CITY OF GAHANNA, FRANKLIN COUNTY, OHIO DESIGN REVIEW PLAN FOR THE MARKET AT ROGER'S CORNERS PARKING EXPANSION 2023

Subject: Project 1379-1391 E Johnstown Rd Design Review/C of A
Response Letter

RE: Project 1379-1391 E Johnstown Rd Design Review/C of A

STAFF REPORT

CITY OF GAHANNA, FRANKLIN COUNTY, OHIO
 DESIGN REVIEW PLAN
FOR
THE MARKET AT ROGERS'
CORNERS
SITE PLAN

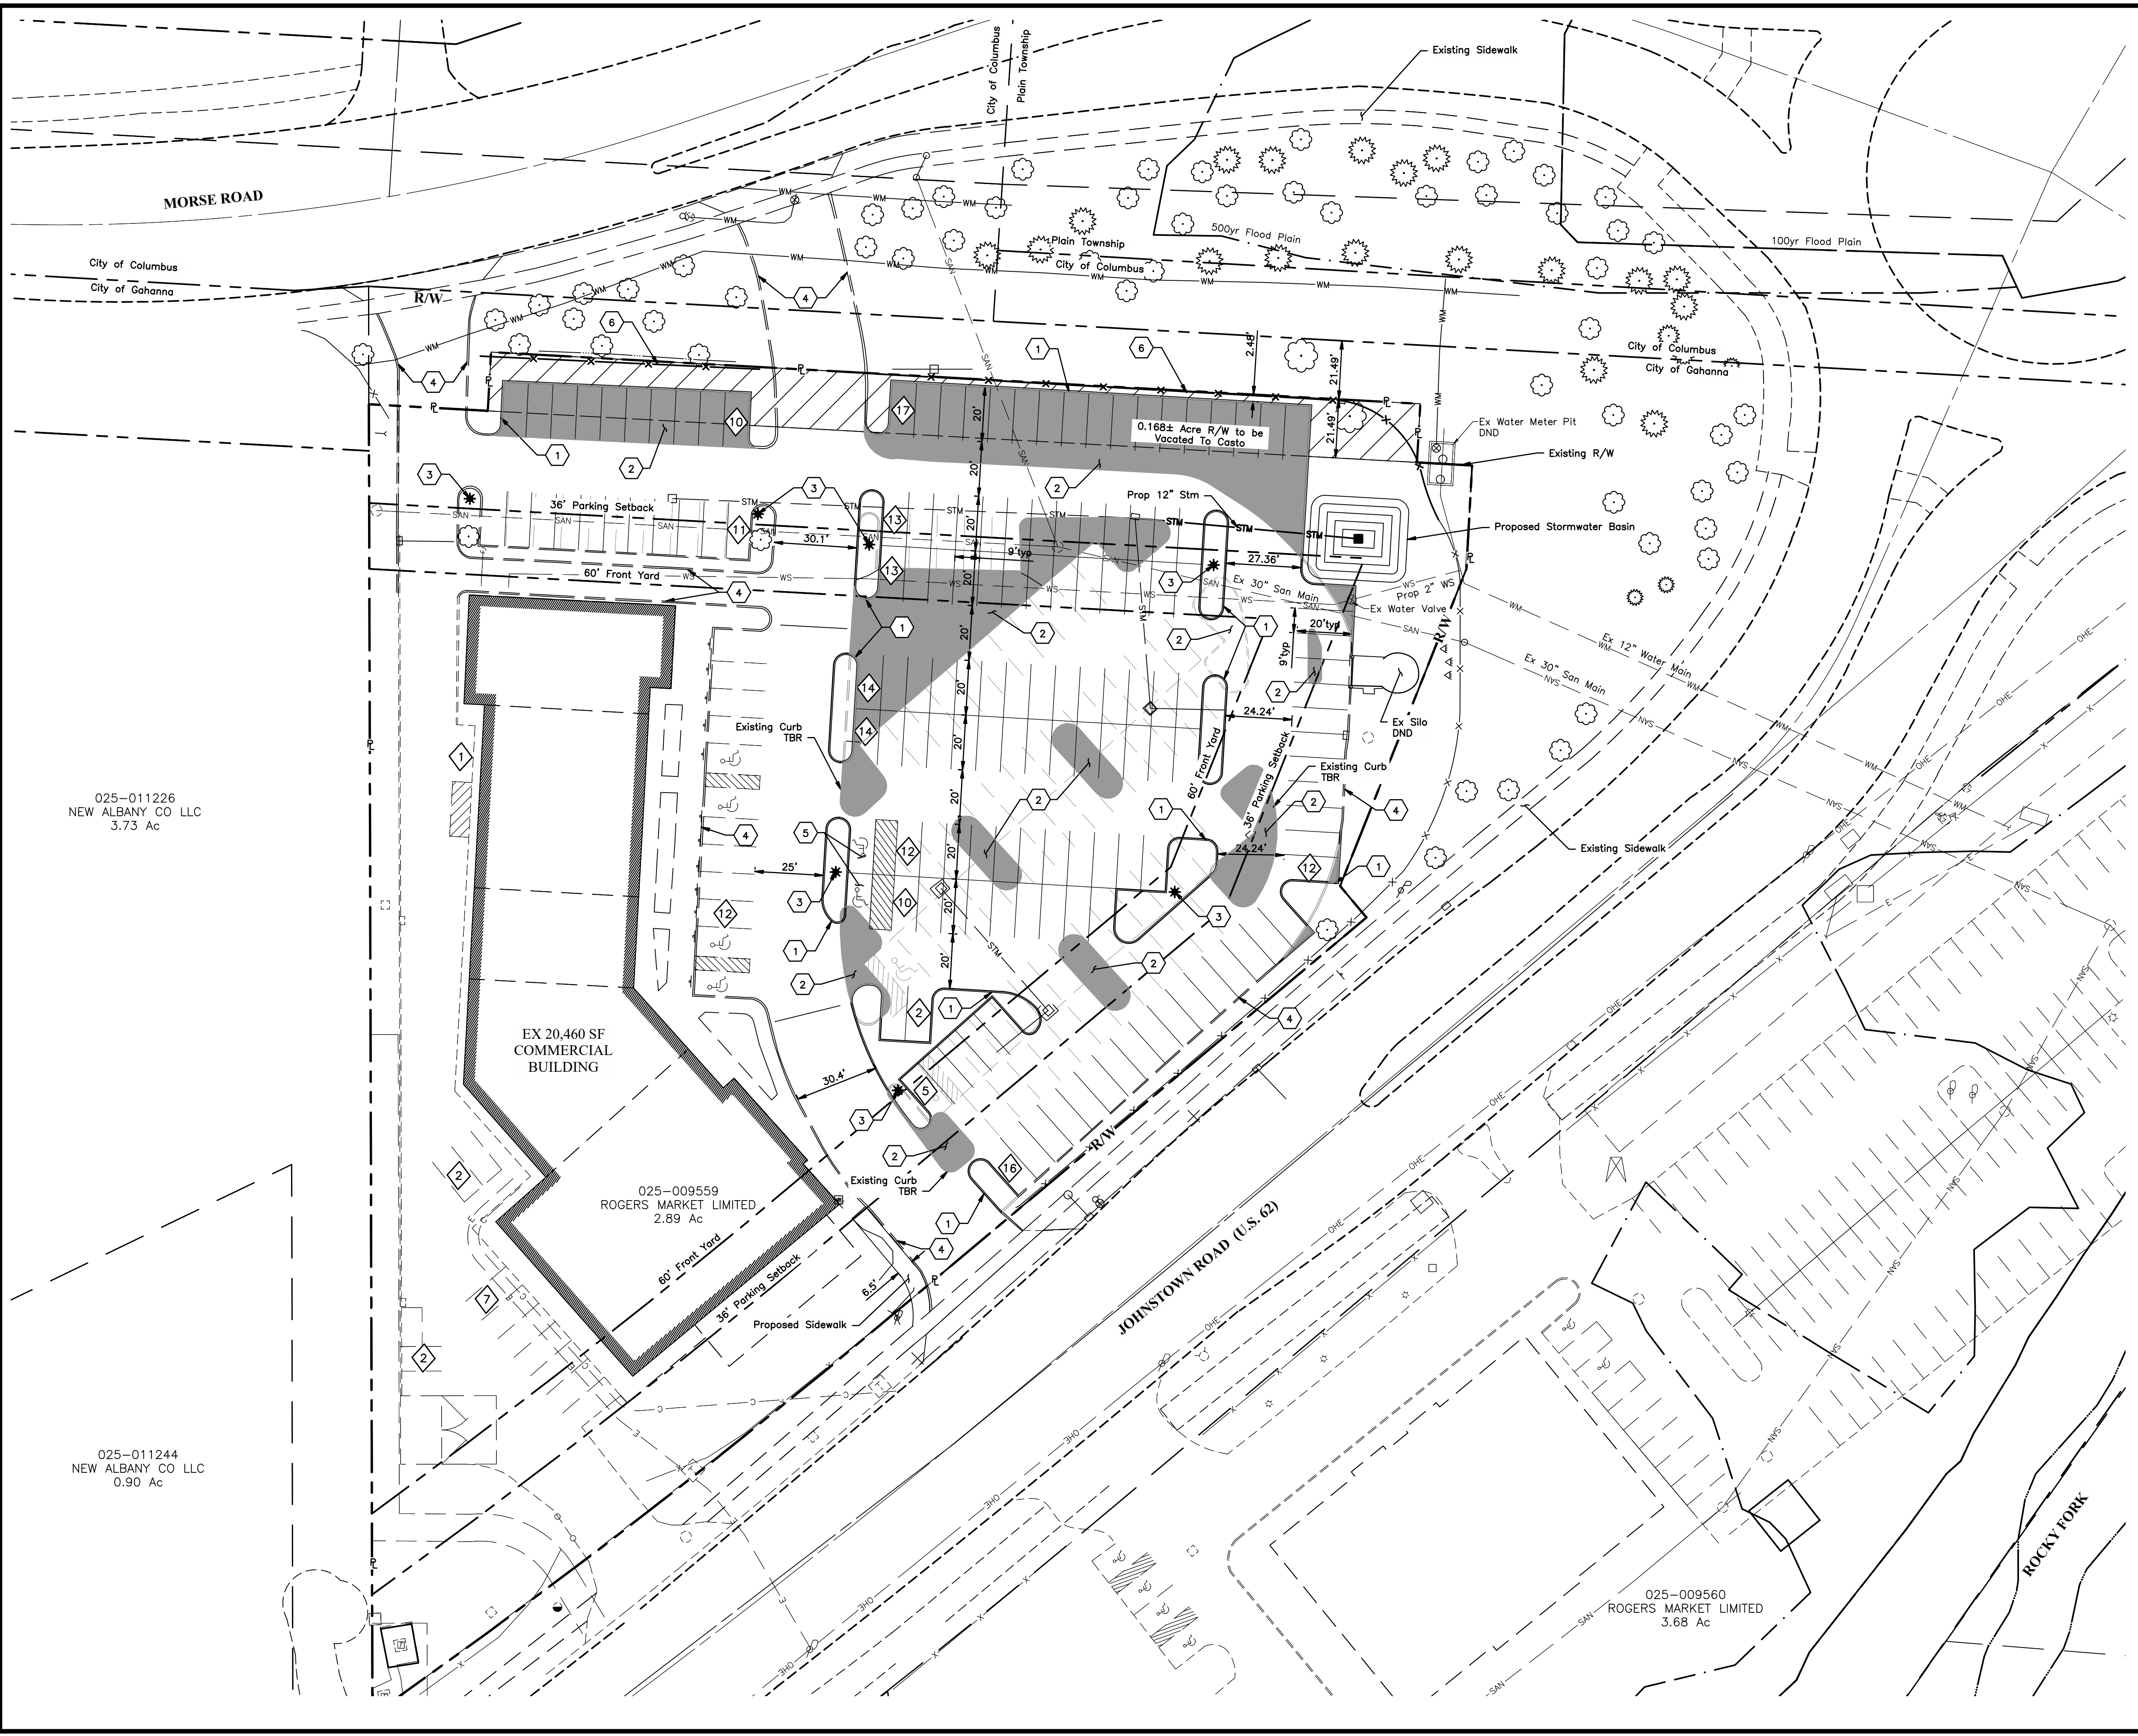
4. Sidewalks shall satisfy ADA requirements for minimum width and other related design standards such as ADA compliant curb ramps.

7. Potential conflict with water line (PV-120) and proposed stormwater basin.

8. Potential conflict with existing sanitary sewer (SA-461) and proposed stormwater basin.

9. Include the locations of sanitary lines and water service lines in the site plan.

11. Please be aware the site plan (sheet 3/6) contains a significant amount of information that isn't approved through a design review application. Please refer to the design review application, Chapter 1197 and 1108.03 for the type of information required. For clarity, please remove the unnecessary/unapprovable information from the site plan (sheet 3/6). Please revise to clearly depict the site post development (e.g., new property lines, parking setbacks, fence location, etc.). Please be aware that additional comments may be forthcoming.

12. Chapter 1153.02/1167.15 requires a 60' front yard (north/east/south property lines) and a 36' parking setback. Please revise the site plan to clearly depict. Please revise the variance application to request a variance if necessary.

Response: Proposed sidewalk width shown on plan (sheet 3). There are no proposed sidewalk ramps.

Response: No conflict with proposed basin and existing water line. See sheet 3.

Response: No conflict with proposed basin and existing sanitary sewer. See sheet 3.

Response: Sanitary lines and water service lines shown on site plan.

Response: Unnecessary underground utilities are no longer shown on the plan. We feel the information currently on the plan is necessary to show a complete layout of the site and is pertinent to the site. New property lines, parking setbacks, and fence locations shown and called out on the site plan.

Response: 60' Front yard and 36' setback shown on site plan. Variance application has been revised and sent with the submittal package.

CITY OF GAHANNA, FRANKLIN COUNTY, OHIO
 DESIGN REVIEW PLAN
FOR
THE MARKET AT ROGERS CORNERS
LANDSCAPE PLAN

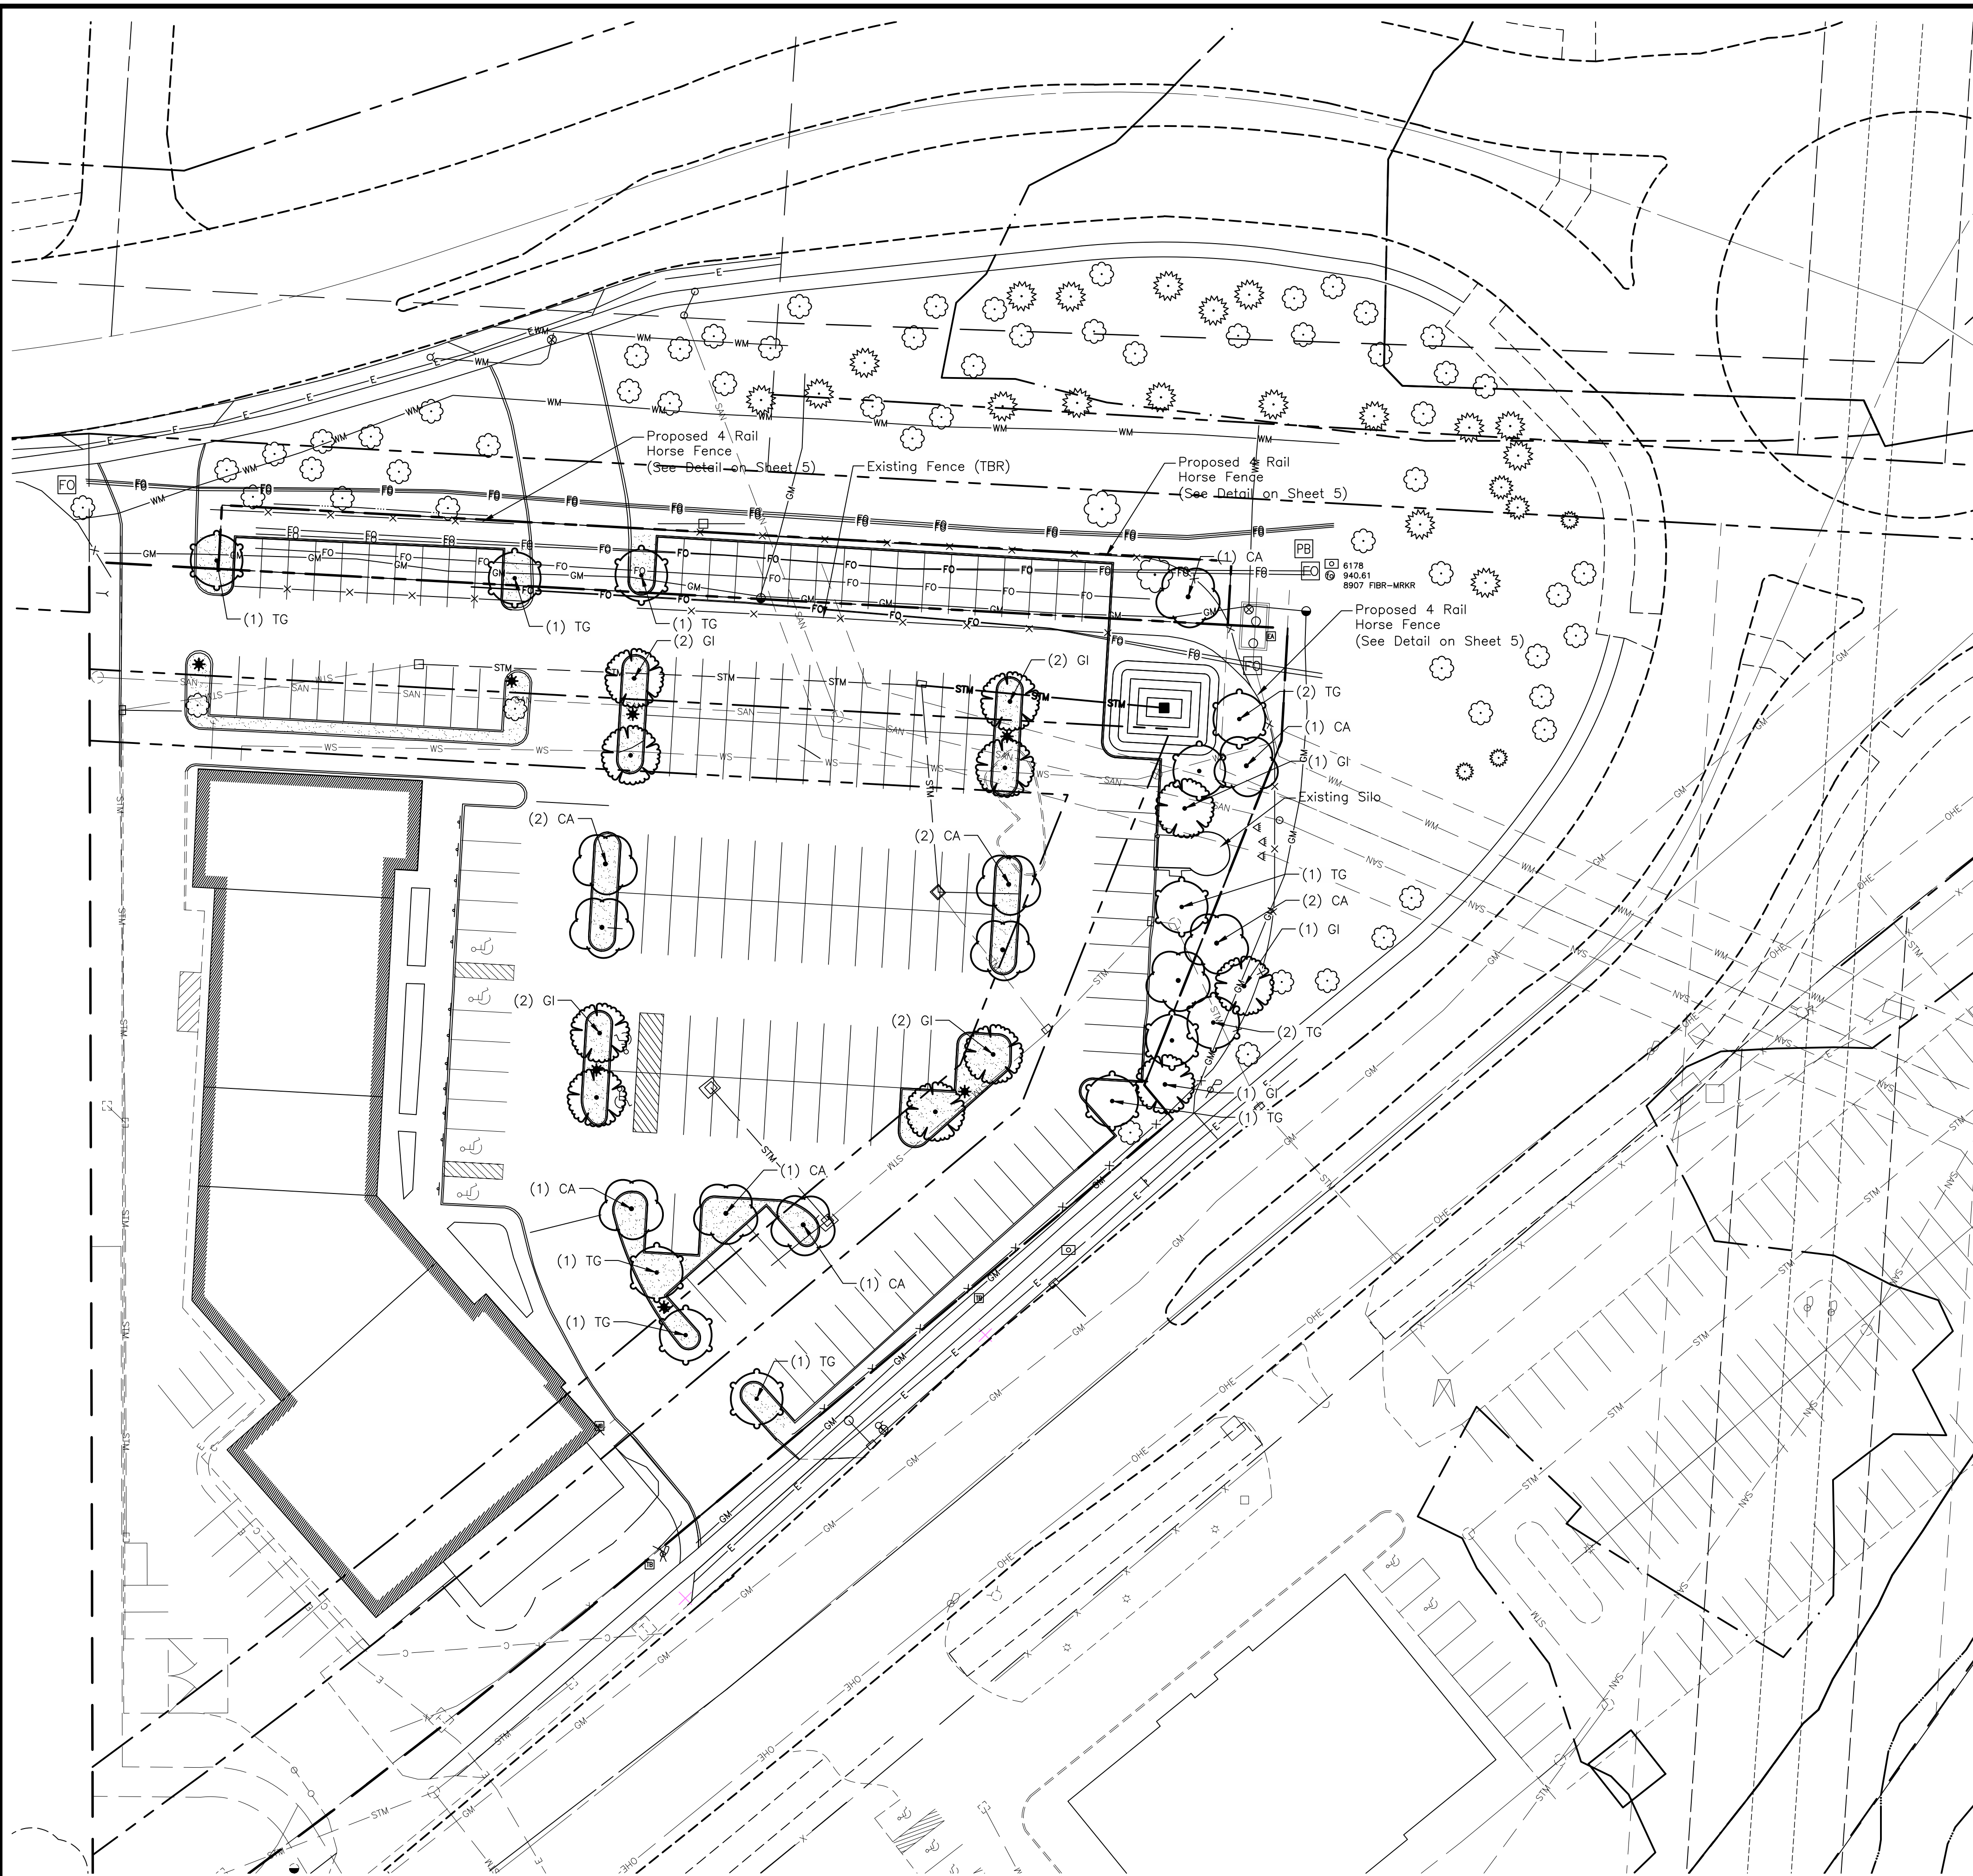
10. Landscape plans look well done. My only concern is about the choice of tree species. Honey locust and linden are both acceptable trees, but honey locusts are prone to surface roots that sometimes conflict with pavement. Lindens are prone to low hanging branches that could be difficult to keep pruned up in a parking lot setting.

14. The landscape plan contains a reference to Chapter 1155.06. Please be aware that this code requirement applies to properties zoned Office, Commerce, and Technology (OCT). Since the property is zoned Neighborhood Commercial (NC), this is not a requirement that applies to this request. The applicant may remove these landscaping improvements if desired.

Response: Tree species listed are part of the approved trees by city of Gahanna and have small leaves that will better minimize debris in the parking lot during the fall.

Response: Landscaping requirements pertaining to 1155.06 removed from plan.

Four Rail Horse Fence
No Scale

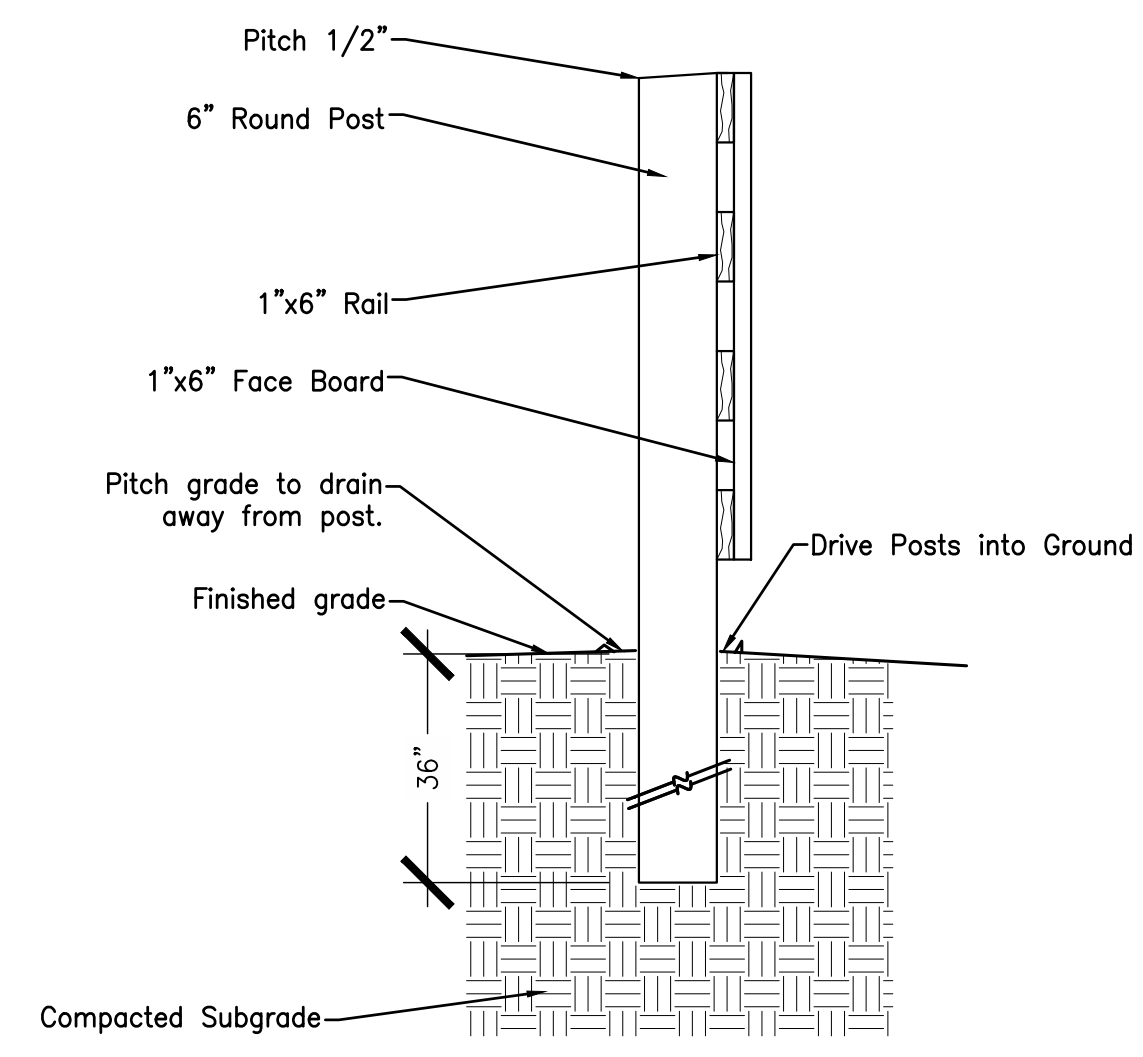
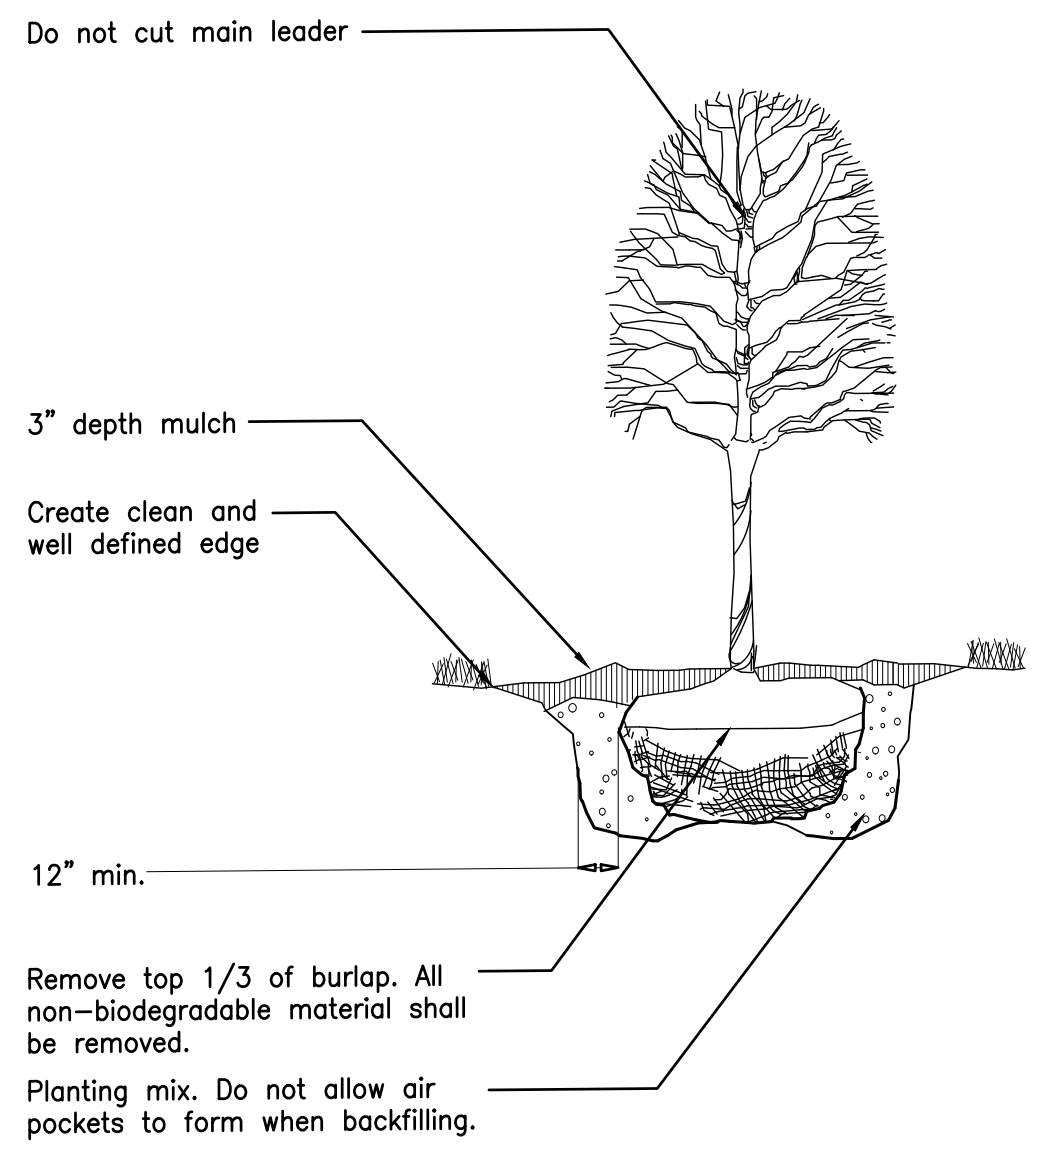
13. Sheet 5 depicts a 54" fence in the front yard(s). Chapter 1171.03(f) permits a maximum fence height of 42". A variance will be required if the fence is located in the front yard. Please revise the site plan to clearly depict fence location. Please revise the variance application as necessary.

4. Sheet 5 depicts a 54" fence in the front yard(s). Chapter 1171.03(f) permits a maximum fence height of 42". A variance will be required if the fence is located in the front yard. Please revise the site plan to clearly depict fence location. Please revise the variance application as necessary.

Response: Current fence is 54". Variance application has been revised and sent with the submittal package.

3/7/23 - Staff incorrectly read/interpreted the cited code. Since the property is zoned commercial, a decorative fence at 54" in height is permissible. Staff will modify the variance application accordingly.
